MEETING SUMMARY FOR THE SAFETY EVALUATION REPORT OPEN ITEM MEETING,
DECEMBER 21, 1982

The purpose of this letter is to summarize the resolution of items discussed between the Nuclear Regulatory Commission and the Clinch River Breeder Reactor Plant Project on December 21, 1982.

AGREEMENTS AND COMMITMENTS

SER OPEN ITEM MEETING

FIGURE A-2 WALL LINER - AXISYMMETRIC MODEL;
DISPLACEMENT AT 900°F.

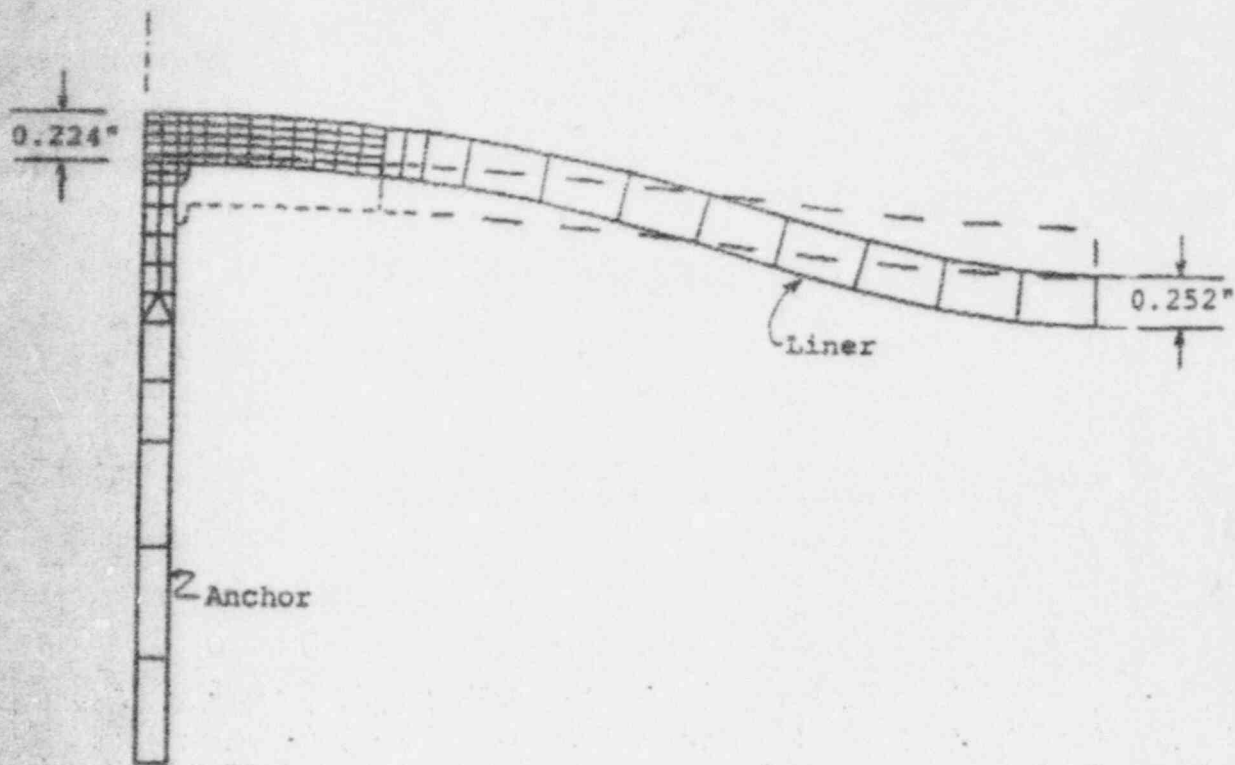
STIF 42 axisymmetrical ANSYS elements were used for plate and stud. The interface (gap) between liner and concrete was represented by STIF 12 elements. A rigid beam (represented by BEAM 3) was used to connect the nodes of the five layer elements to those of the one layer, at the radius of 1.875 inches. Boundary conditions at the plate edge were: free out-of-plane displacement and fully restrained radial displacement and edge rotation. The stud end was fully restrained. The results of the analysis in terms of equivalent von Mises strains are given in Figure A-1.

The maximum equivalent von Mises strains are .023 in/in for the plate and 0.045 in/in for the stud. These are below the limits established by the Criteria.

The maximum out-of-plane shear stress in the plate is 11.7 ksi at the section adjacent to the stud weld (lower element).

The maximum out-of-plane shear stress is 0.45 of the yield strength of the material at the 900°F temperature. The average out-of-plane shear stress in the same plate section is 8.4 ksi or 31% of yield. The maximum shear stress in the weldment is 14.6 ksi. Figure A-2 shows the deflected shape of the model. Figure A-3 lists stresses at some elements in the vicinity of the stud.

FIGURE B-1 WALL LINER TYPICAL PANEL - CHECKERBOARD BUCKLING - STRAINS AT 900°F (Membrane, Membrane + Bending) In/In

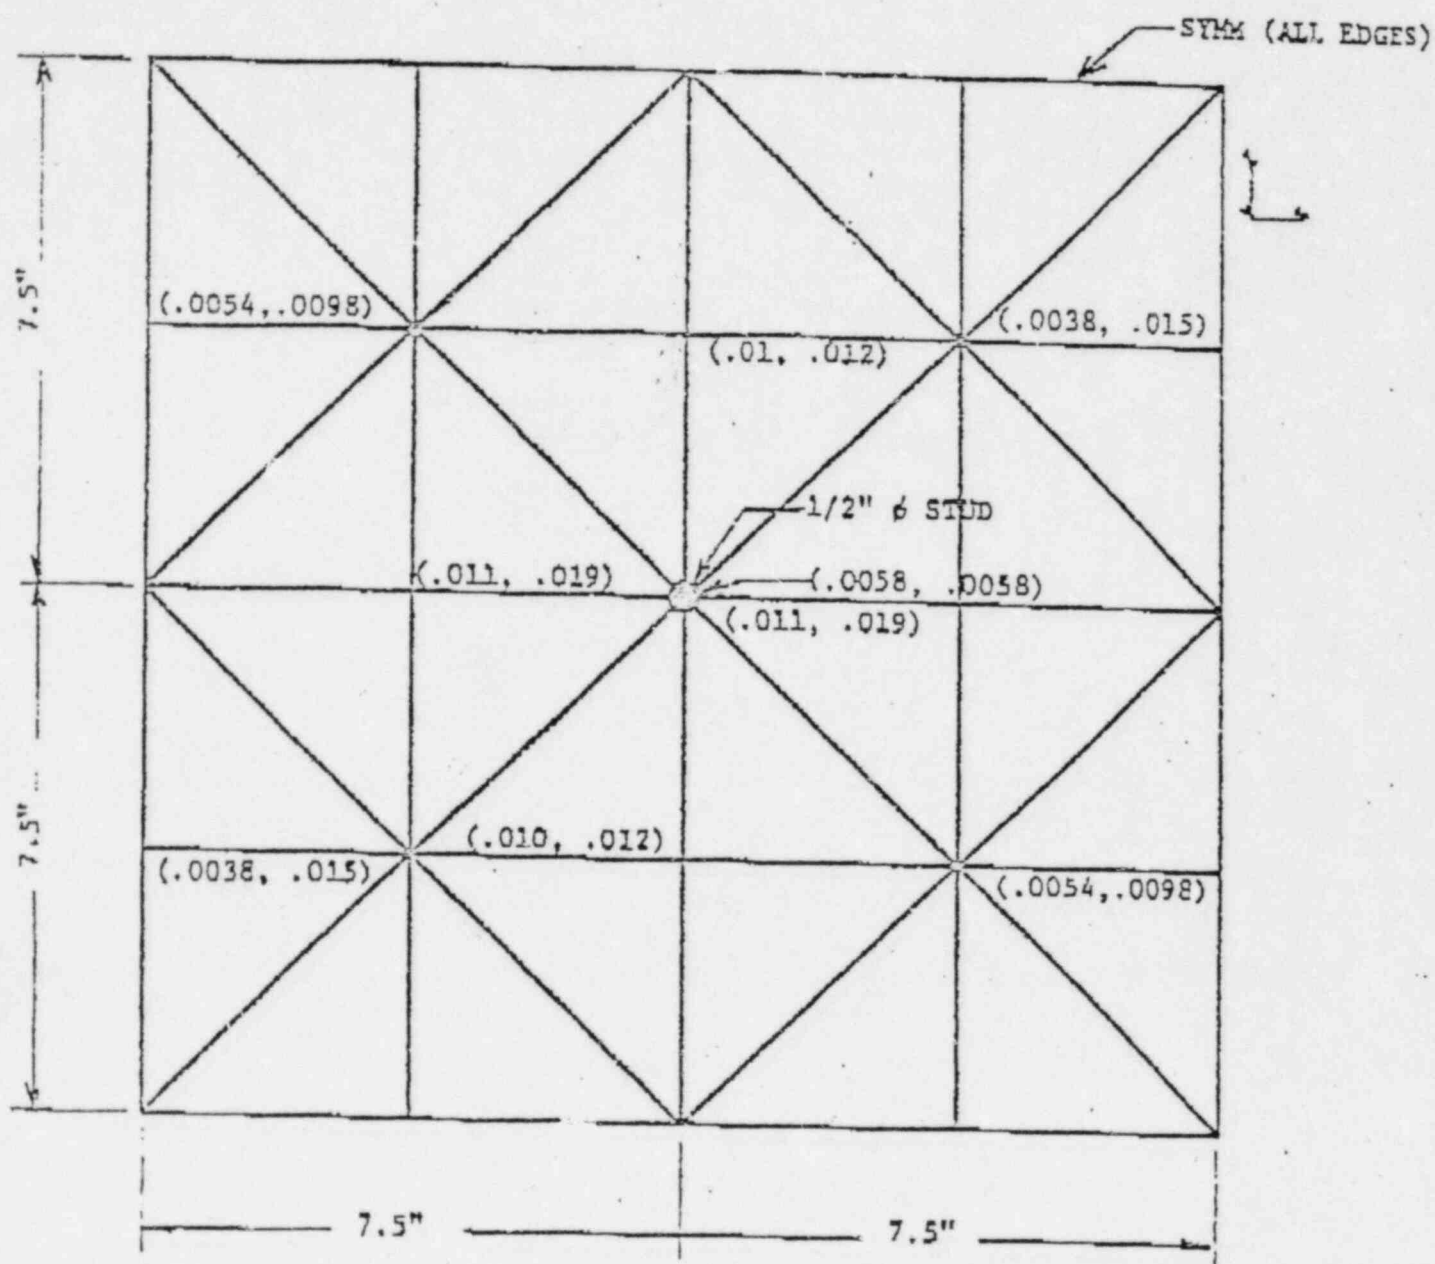
An evaluation of the strain conditions under a checkerboard pattern of buckling with the mathematical model of Figure B-1 was performed. It consists of a 15 inch square plate panel with a stud at the center. (Fifteen inch is the spacing between studs). The boundary conditions at the edge of the plate are: free out-of-plane displacement, and full restrained in-plane displacement and edge rotation. The following ANSYS elements were used in the model: STIF 46 for plate, STIF 20 and STIF 8 for studs and STIF 12 for gaps between plate and concrete. To induce the desired buckling pattern a 1 lb. force was applied at the diagonal corners that displaced away from the concrete. The other two diagonal corners displaced in the opposite direction.

Figure B-1 shows the maximum strains and Figure B-2 the displacement contours. The maximum equivalent von Mises strains are:

Plate: 0.011 in/in (Membrane), 0.019 in/in (Membrane + Bending)

stud: 0.0058 in/in (Membrane and Membrane + Bending)

The strain allowable limits in accordance with the liner criteria are 0.070 in/in for membrane and 0.094 in/in for membrane plus bending strains. A comparison of the results of this case with that of unsymmetrical buckling (Response to Audit Finding I.A.1d) shows that the latter imposes higher strains on the liner and stud.
